3085 WOODBINE ROAD
 WOODBINE, MD 21797
 PARCEL 223, MAP 13, 6.78 ACRES
 PLAT 11780, WARFIELD RIDGE
 ONSITE SEWAGE DISPOSAL DESIGN PLAN

DATE: 12/18/2024
TO: Dylan Strother
3085 Woodbine Rd.
Woodbine, MD 21797
FROM: Robert Freemon
Well & Septic Program
RE: Perc Results
3085 Woodbine Rd.
Woodbine, MD 21797

From: Freemon, Robert
Sent: Thursday, December 19, 2024 10:48 AM
To: Dylan Strother; Sarah Strother; Jim Witmer
Cc: Silvast, Zackary; Williams, Jeffrey
Subject: RE: 3085 woodbine - Well inspection
Attachments: Perc Results & Data_241219_104445.pdf; Site Plan_241219_093107.pdf

3085 WOODBINE ROAD
 WOODBINE, MD 21797
 PARCEL 223, MAP 13, 6.78 ACRES
 PLAT 11780, WARFIELD RIDGE
 PERCOLATION CERTIFICATION PLAN

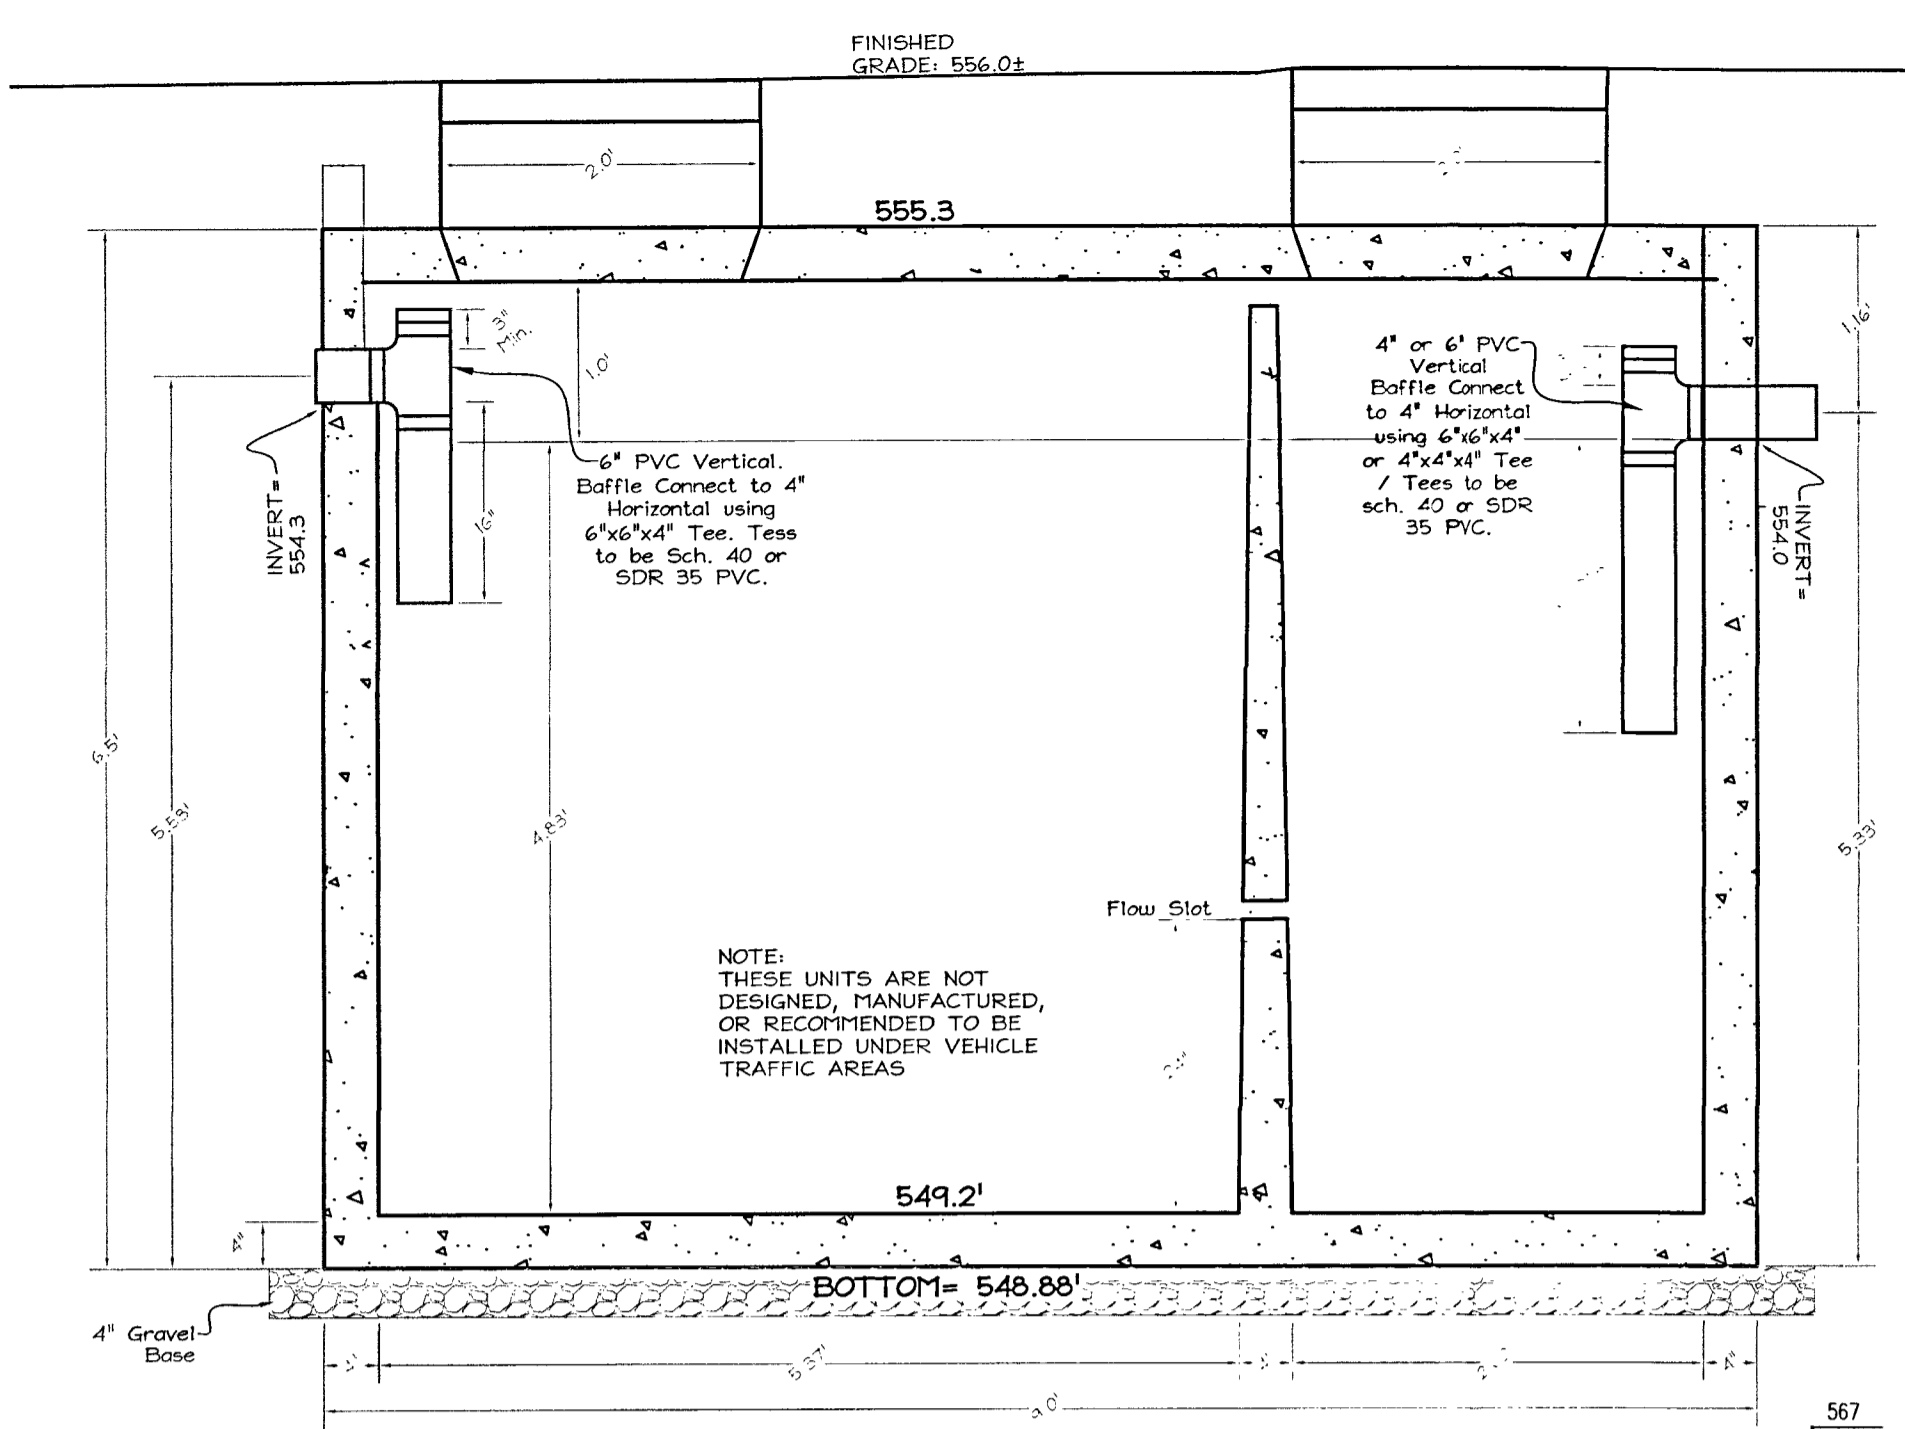
Jim,
On the PC plan have your signature/stamp block, Health Dept. signature block and a signature block for the property owner all together in one of the bottom corners. Due to the circumstances surrounding this property we need it made clear that everyone involved in this project is understanding of the situation at hand. On the PC plan the following notes should be provided.

Jim,
Attached is the perc results letter along with the data collected. On the PC plan have your signature/stamp block, Health Dept. signature block and a signature block for the property owner all together in one of the bottom corners. Due to the circumstances surrounding this property we need it made clear that everyone involved in this project is understanding of the situation at hand. On the PC plan the following notes should be provided.

Jim,
On the PC plan have your signature/stamp block, Health Dept. signature block and a signature block for the property owner all together in one of the bottom corners. Due to the circumstances surrounding this property we need it made clear that everyone involved in this project is understanding of the situation at hand. On the PC plan the following notes should be provided.

2. A qualified licensed OSDS designer will need to evaluate the areas of the property that did not pass conventional perc testing and identify a potential area and method for sewage disposal for future replacement systems. The portion of the property currently within a forest conservation easement may still be explored for possible future sewage disposal area depending on determination and requirements from the Department of Planning and Zoning, and ultimately suitable and soil conditions. This area has not yet been tested to determine whether it can support conventional OSDS systems. If an area is not identified, a holding tank may be required when the initial system fails. (This note is to combine notes 2 & 3 from my previous email)

3085 WOODBINE ROAD
 WOODBINE, MD 21797
 PARCEL 223, MAP 13, 6.78 ACRES
 PLAT 11780, WARFIELD RIDGE
 ONSITE SEWAGE DISPOSAL DESIGN PLAN

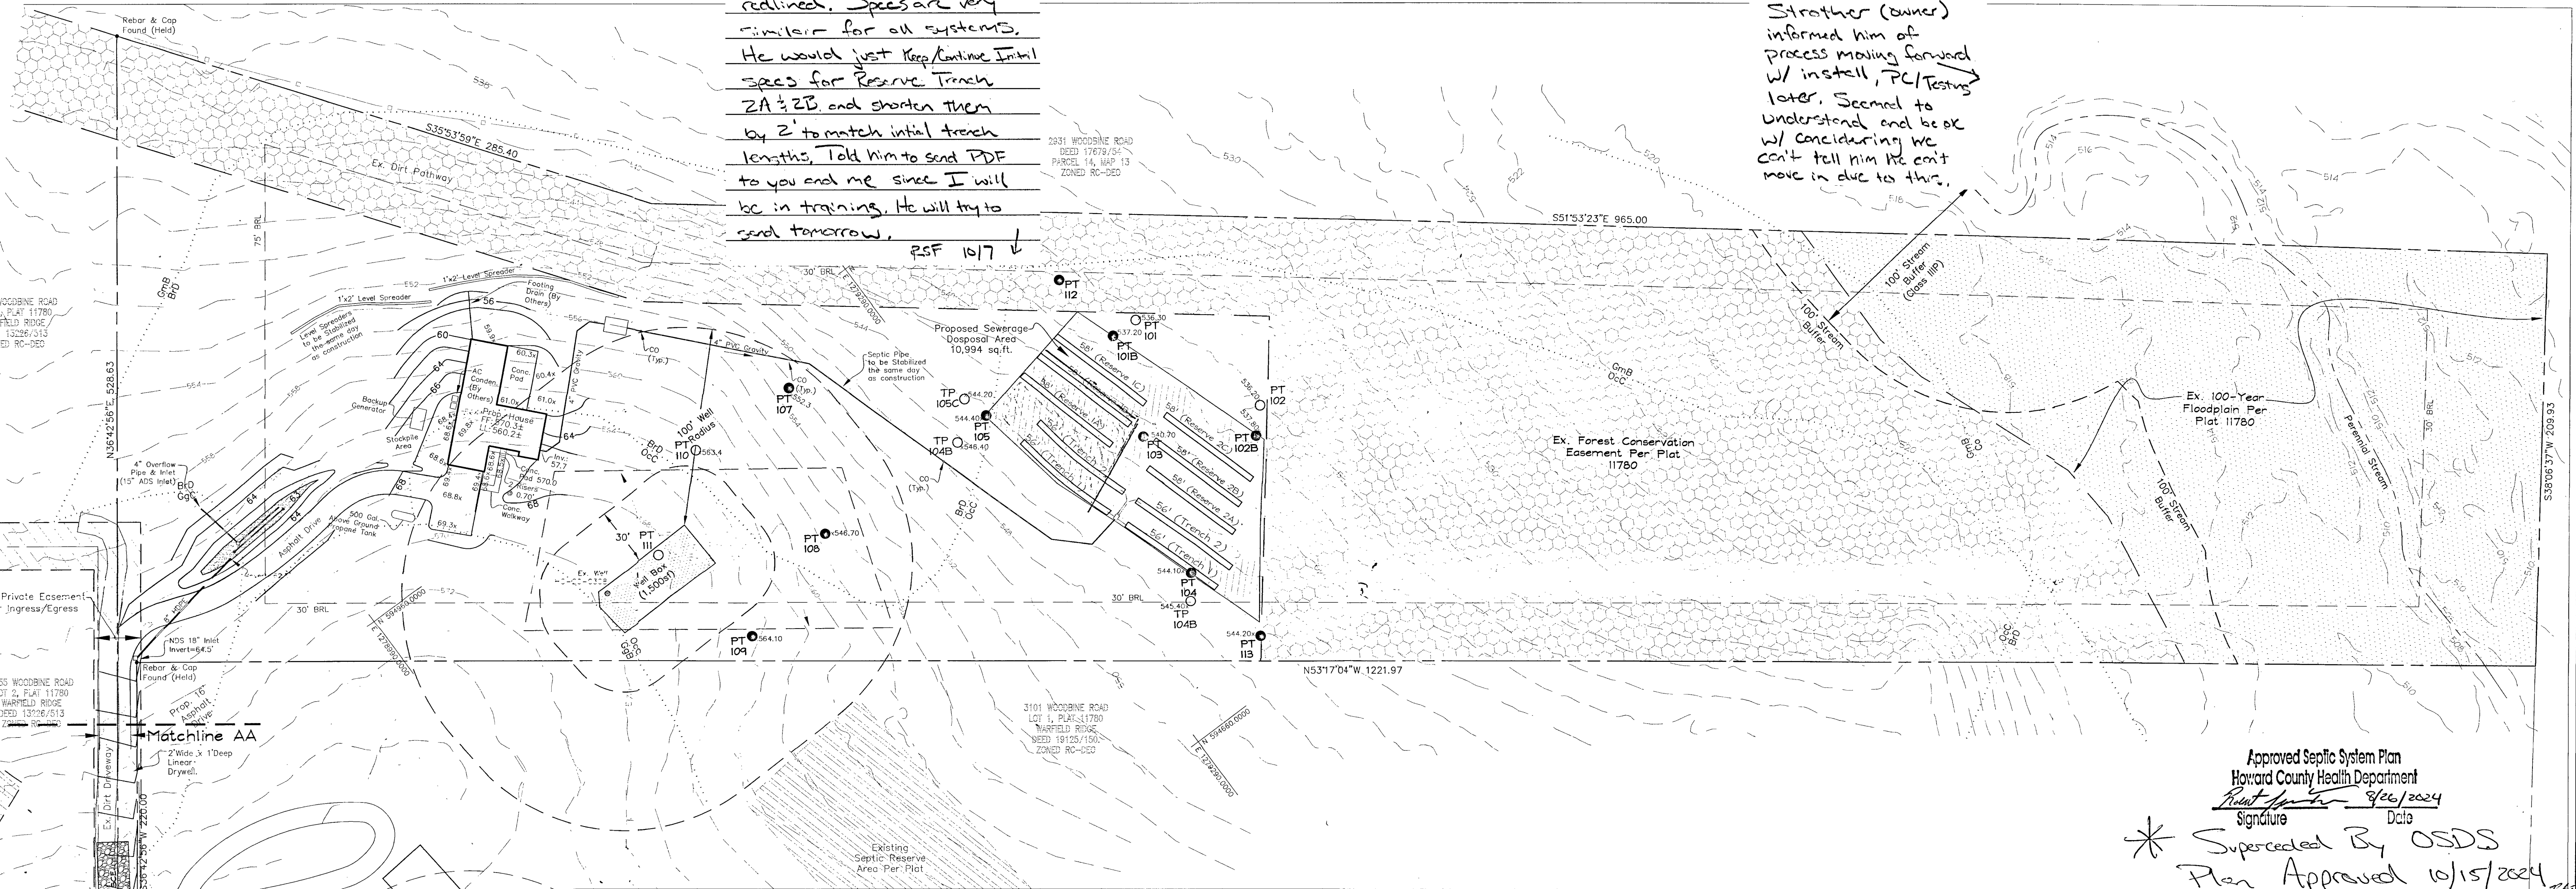
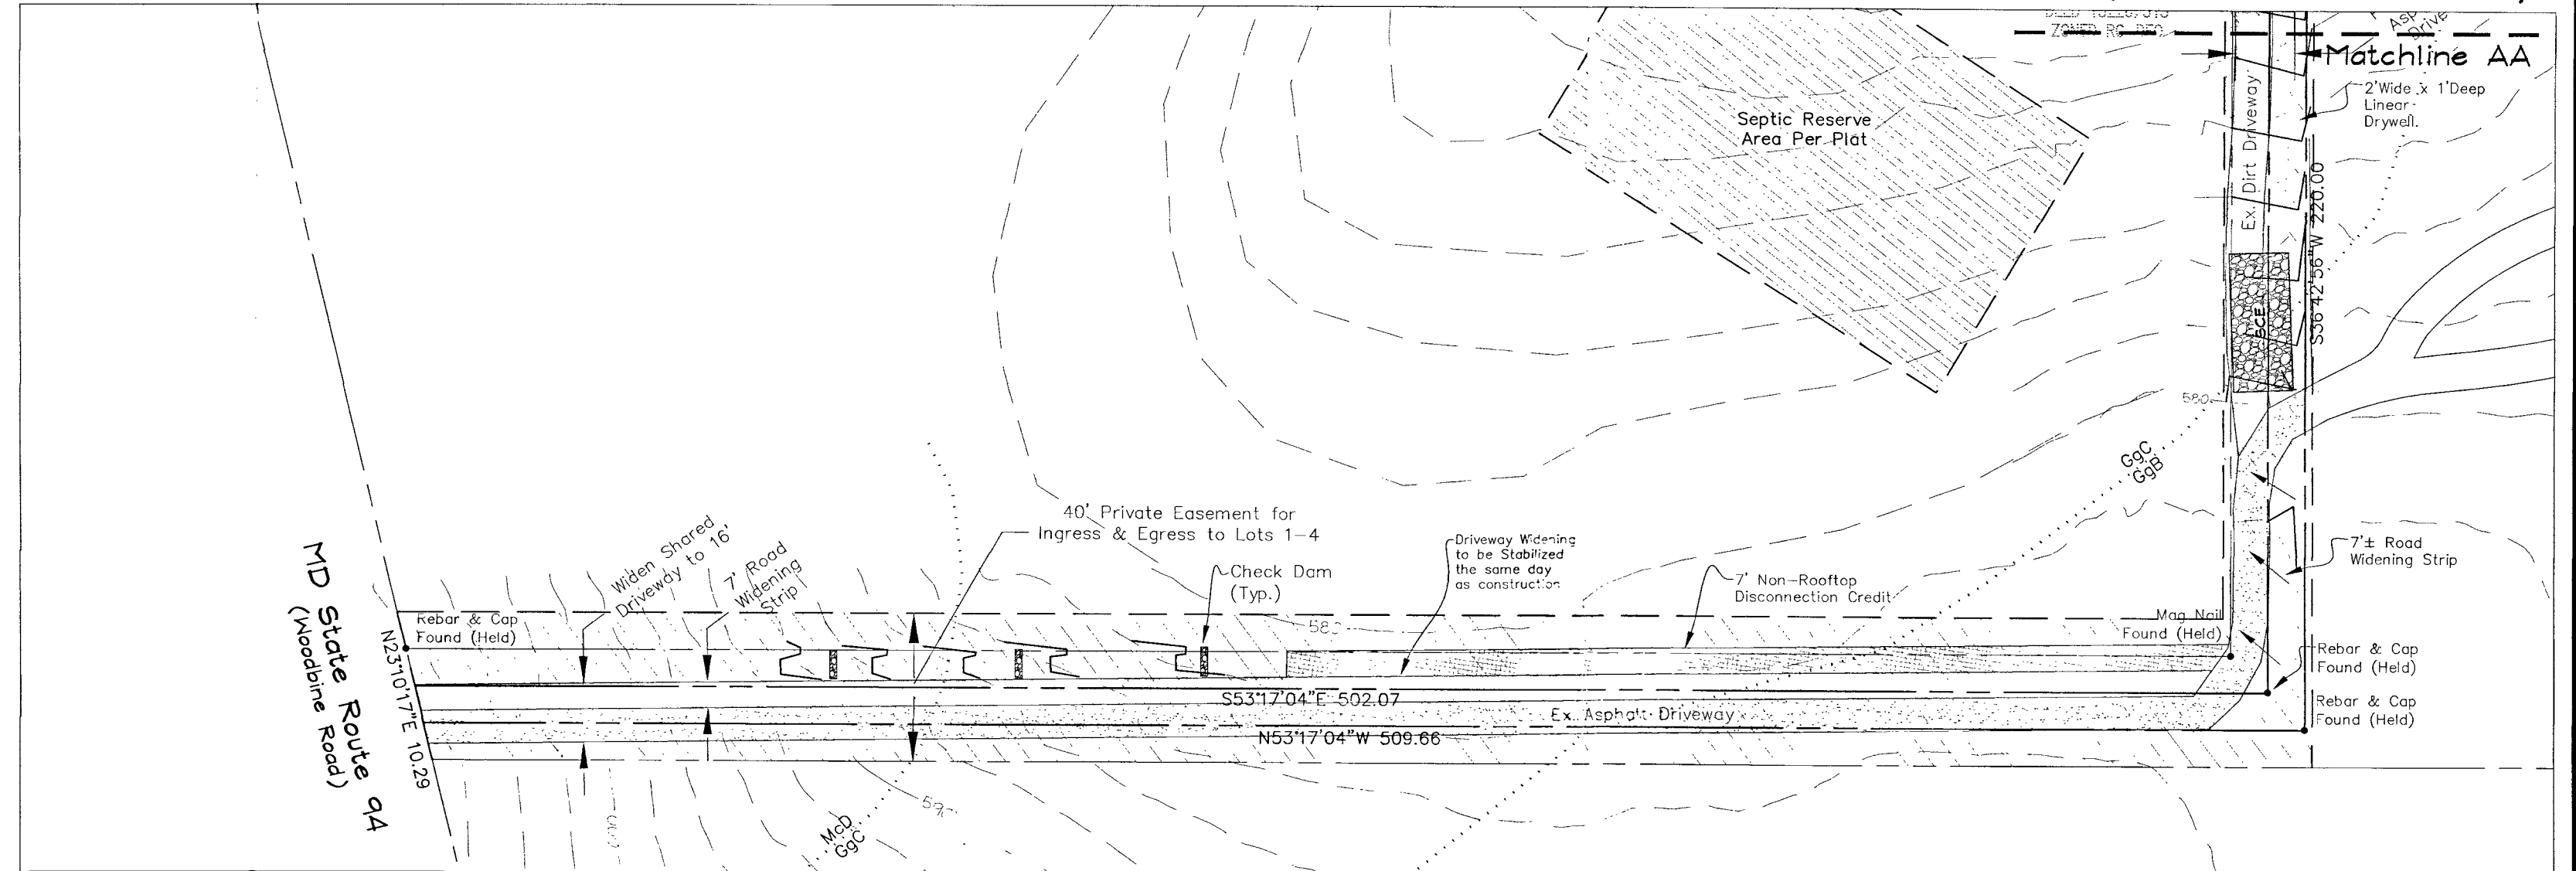
Approved Septic System Plan
 Howard County Health Department
 Signature: [Signature] Date: 8/26/2024

* Superseded By OSDS
 Plan Approved 10/15/2024
